CITY OF NAPOLEON - BUILDING DEPARTMENT 255 West Riverview Avenue, Napoleon, Ohio 43545 - 419-592-4010

Job Location 537 High St.

RESIDENTIAL PLAN CORRECTION SHEET

Owner BECK'S CONSTRUCTION
Contractor BECK'S CONSTRUCTION
Location 577 HIGH ST

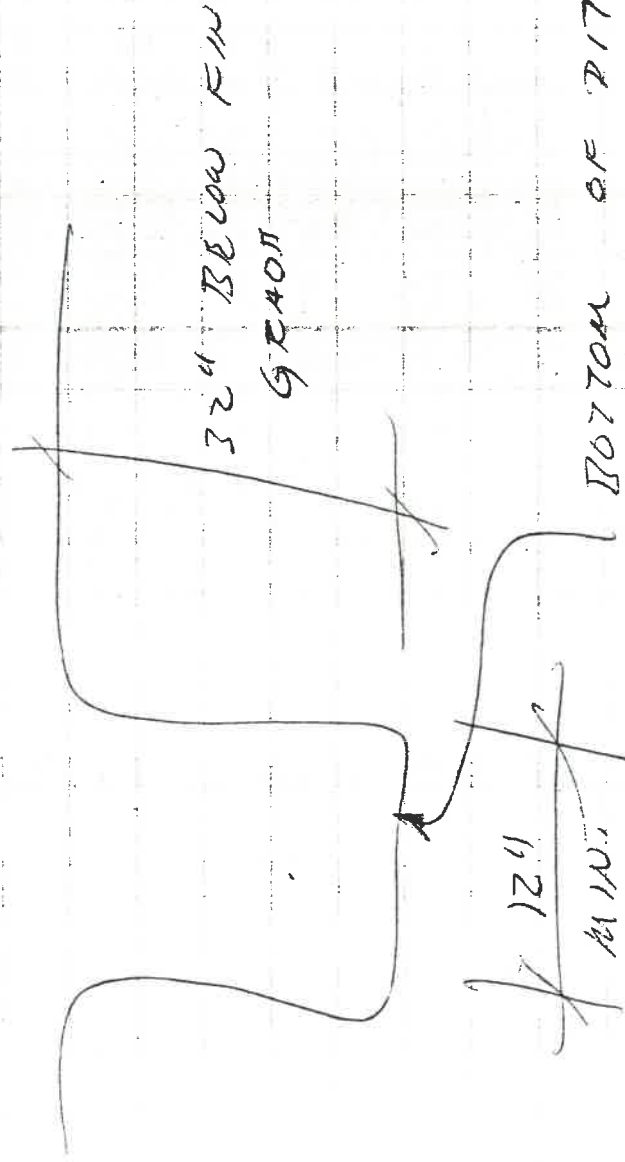
CHECKER SET BACKS O.K.

WIDTH OF FOOTER O.K.

DEPTH OF FOOTER O.K. *

* NOTE: S.E. CORNER ONLY

24" BELOW EXISTING - SHOULD
WATCH FINISH GRADIENTS OBTAIN
32" COVER

REBAR - 3 ROWS $\frac{1}{2}$ " REBAR PROVIDED
ENTIRE PERIMETER WITH 24" $\approx$ 36"
OVERLAP ON ENDS. VERTICALLY POSITIONED
10 MIN. S.

PLACED PER FOOTERS, BUT NO BAR USED

STARTED RAISING WALLS UPON COMPLETION OF

POUR FOR APPROX. 5 MIN. - COULD AFFECT
STRENGTH IN UPPER ~~PORTION~~ ^{1"} OF FOOTER BUT
NOT ENOUGH TO AFFECT STRENGTH OVERALL
